Comment Resolution for the MR-O-QPSK PHY

IEEE P802.15

Re: Task Group 15.4g LB51 comment resolution

Abstract: Comment resolution for the MR-O-QPSK PHY

CID 1470

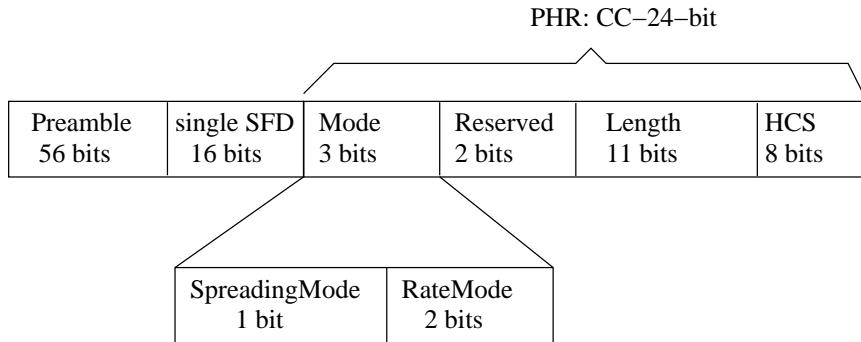
- ▶ Comment:
 - ▶ During PHR reduce spreading gain but introduce FEC.
- ▶ Response:
 - ▶ Accept in principle.
- ▶ Resolution:
 - ▶ FEC based on terminated and interleaved convolutional coding
 - ▶ Option B
 - ▶ pilots in order to simplify Viterbi decoding
 - ▶ For details see doc # 15-10-0435-02-004g
